Botley West Solar Farm

Secretary of State RFI - Applicant's Response

PINS Ref: EN010147

Document Ref: EN010147/APP/20.3

Figure 2 – Incremental Farmoor Land Holdings in Blue, the additional Land Holdings in Red within the Focused search area boundary in Black.

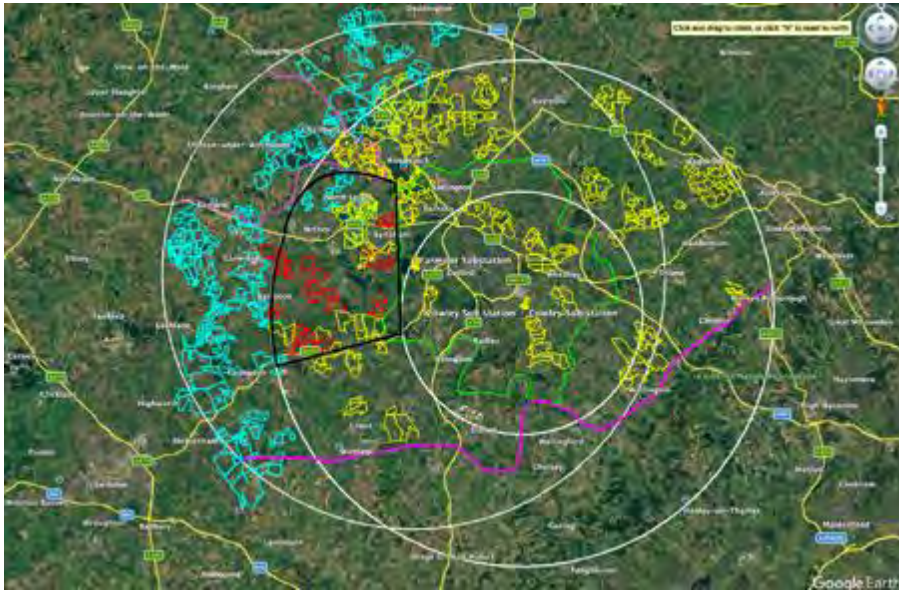
Search for Land within the Farmoor Area

Following identification of the potential Farmoor substation location, the Applicant applied the same 25km search radius to the proposed Farmoor NGET substation. The incremental Farmoor Land Holdings is shown in Blue in Figure 2. This expanded search area introduced approximately 20 additional landowner prospects with holdings exceeding 250 hectares, representing approximately 14,500 hectares of additional land.

The Focused search area broadly followed the eastern Green Belt boundary and extended to the 15km search limit from the proposed Farmoor NGET substation. The Applicant targeted Land Holdings between 250 and 100 hectares. In Figure 2 the additional land holdings are shown in red and the new Focused search area boundary in Black.

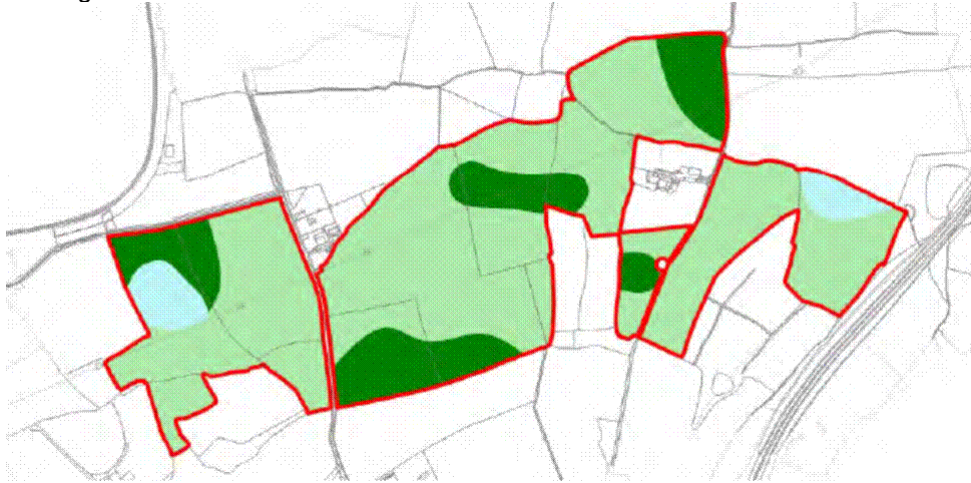
The land within Holding 2 only comprises a single small pocket of BMV as shown below, which would not be farmed in isolation:
